### 7.1.3 TPA/55528- 12 WRIGHT STREET, CLAYTON - CONSTRUCTION OF A THREE-STOREY APARTMENT BUILDING COMPRISING 17 APARTMENTS

This application proposes the development of a three-storey residential building containing seventeen (17) apartments with a basement car park.

That Council resolves to Grant a Planning Permit TPA/55528 for the construction of a three-storey apartment building comprising 17 apartments within the Special Building Overlay at 12 Wright Street Clayton, subject to the following conditions:

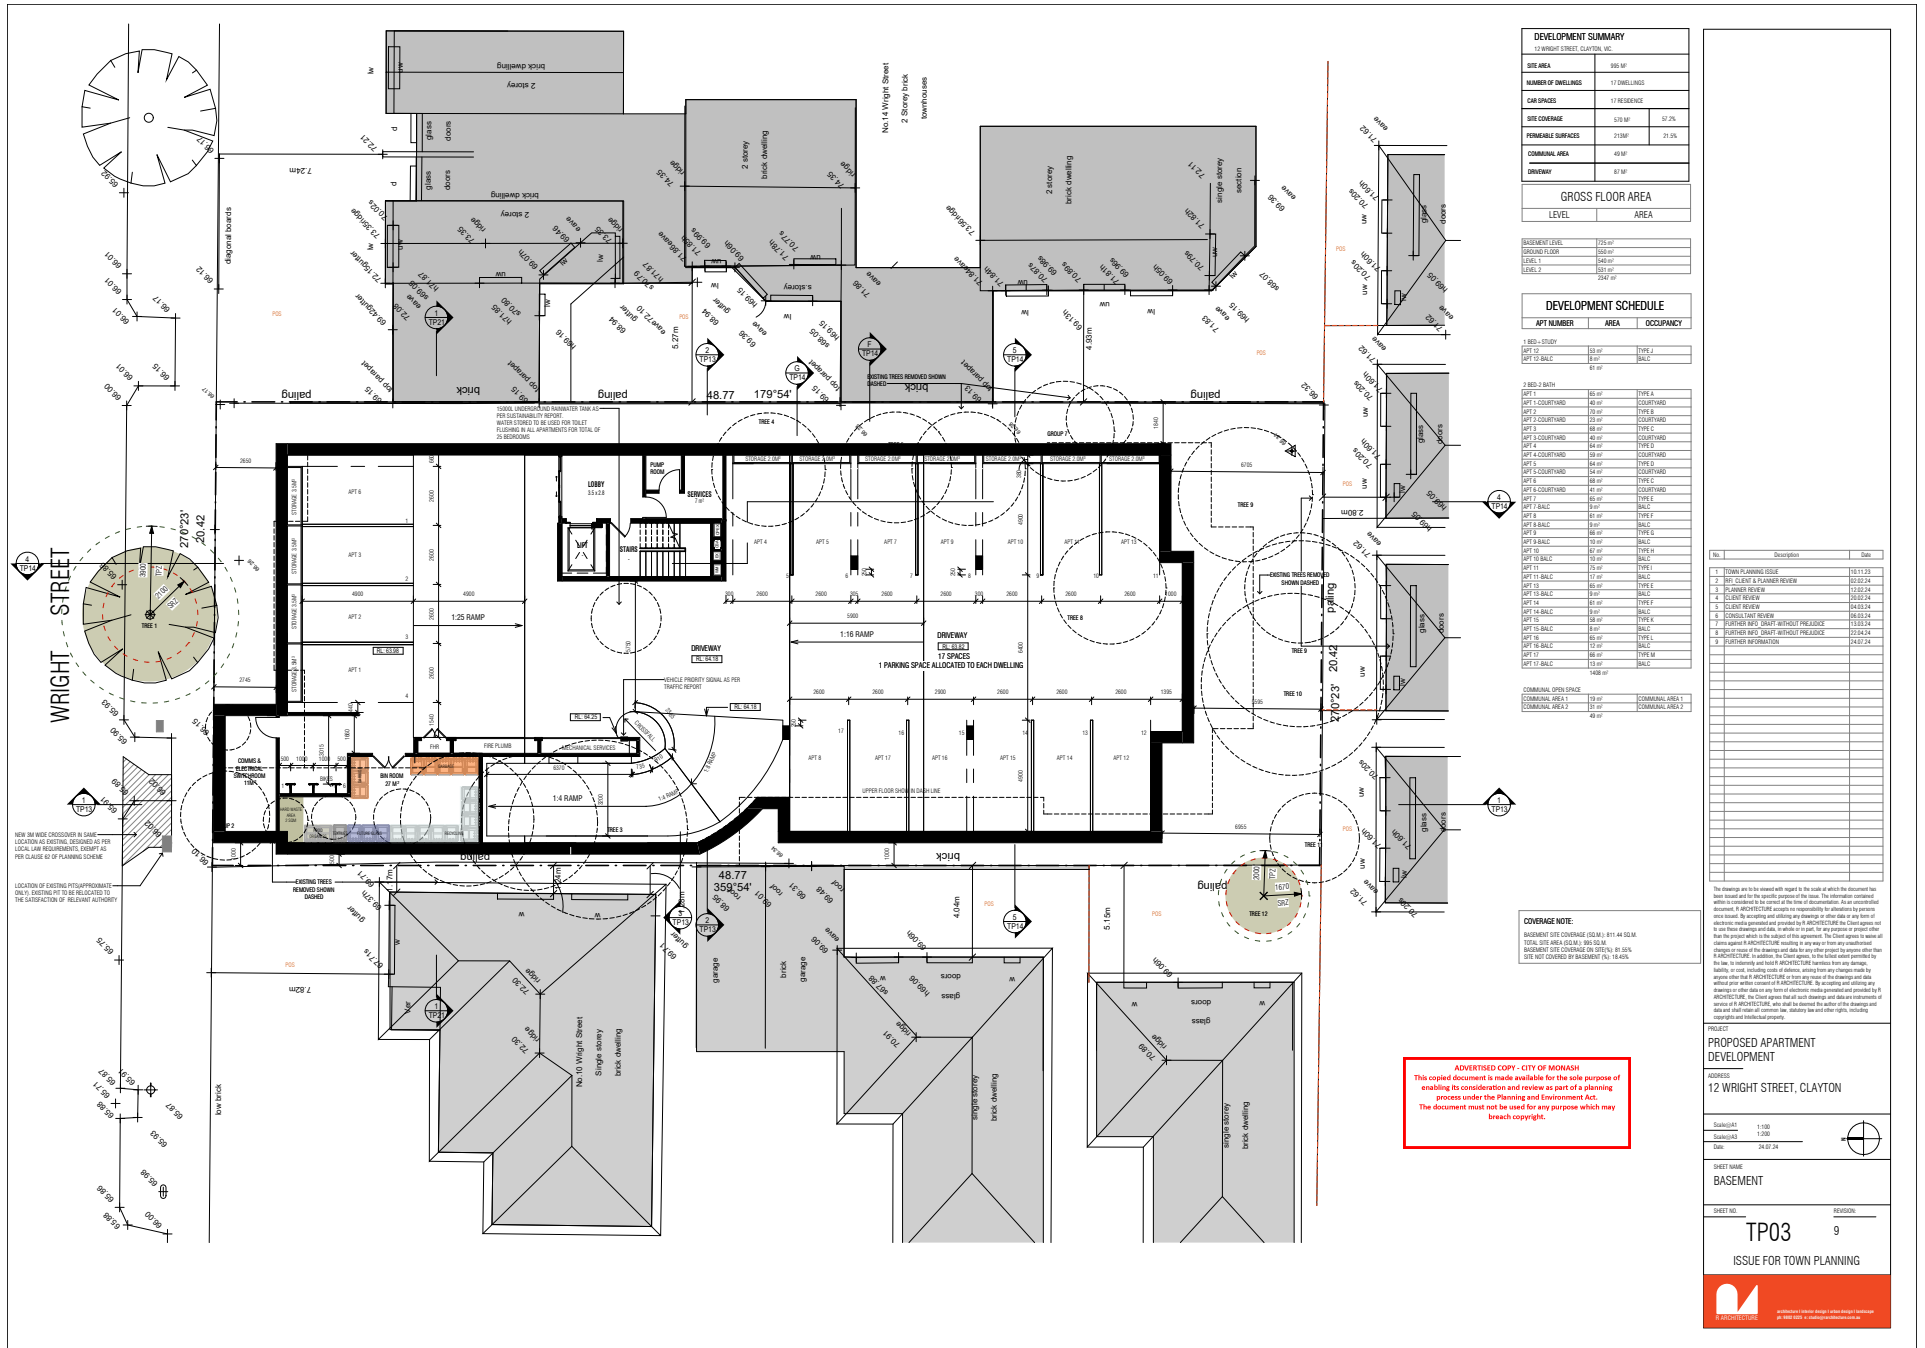
- a) Details of all common boundary fences and demonstration of how overlooking is prevented from the ground floor windows/ sliding doors to comply with Standard B22 *Overlooking objective*.

- e) Ground level bicycle parking relocated away from the front setback area and reduction of hard surface within the front setback to Wright Street.

- g) Location of the substation/ electricity supply and details of any screening/ enclosures to be integrated within proposed front fencing/planter.

- h) The location of tree protection fencing including a notation on the ground floor plan to read 'a tree protection fence must be erected around all trees that are to be retained, including street trees and trees on neighbouring properties. The tree protection fence must remain in place until all construction is completed on the land, except with the prior written consent of the Responsible Authority'.**
  - i) A material and colouring schedule showing details of the façade materials and colours.**
  - j) A Landscape Plan in accordance with Condition 4.**
  - k) An amended Waste Management Plan in accordance with Condition 8.**
  - l) An amended Sustainability Management Plan in accordance with Condition 9.**
- all to the satisfaction of the Responsible Authority.**

SHEET NO: LEVEL 2

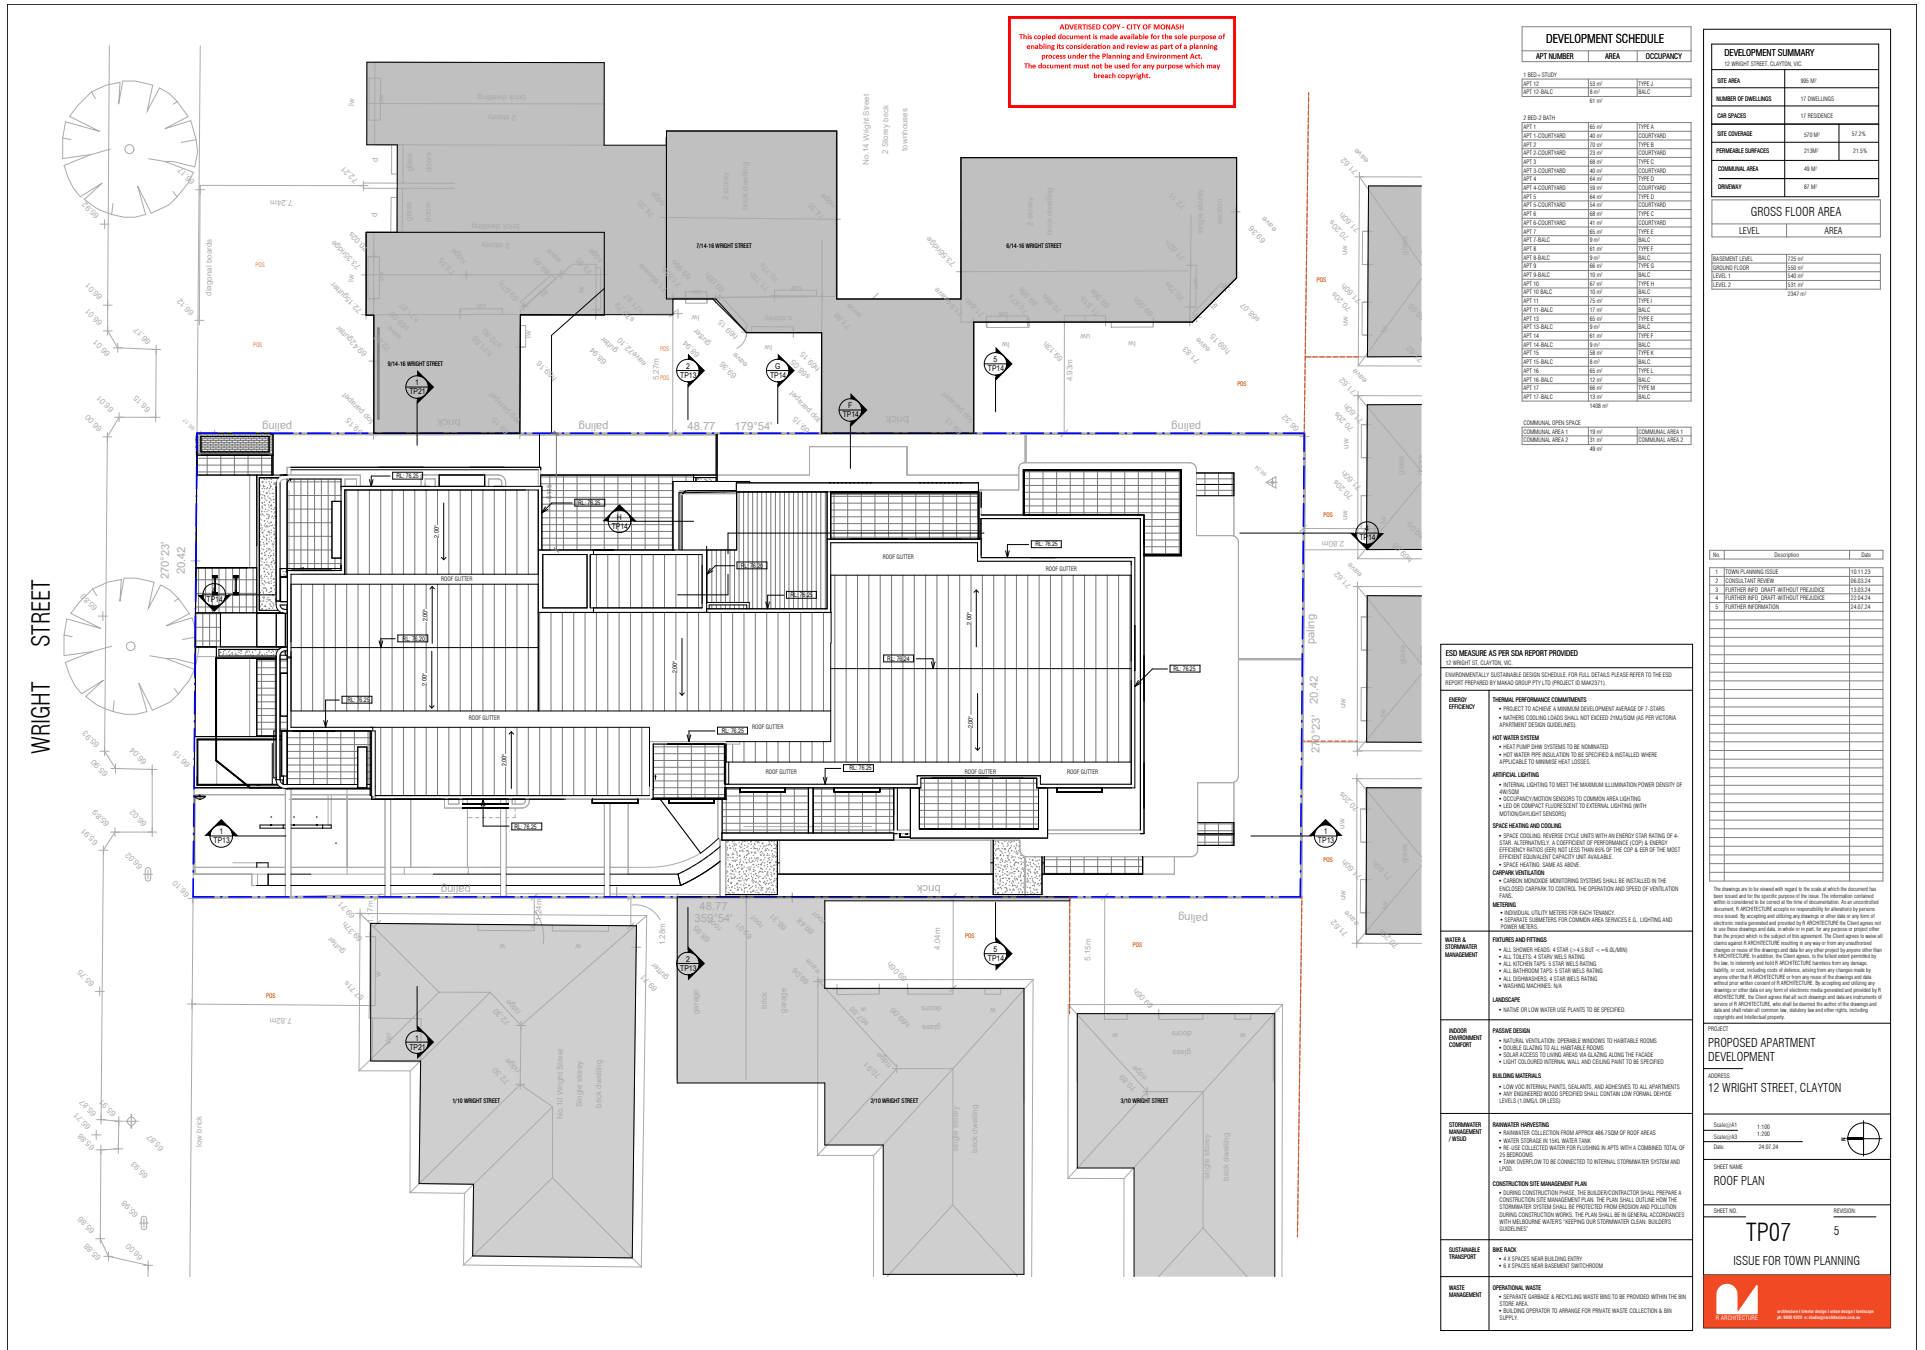
- c) Level 2 setback to the western boundary increased to comply with Standard B17 of Clause 55.04-1 *Side and rear setbacks*.
  - d) The living room/ kitchen of Apartment 1 internally reconfigured and/or acoustic measures implemented to reduce noise impact from the lift and satisfy Standard B41 *Noise impacts objective*.
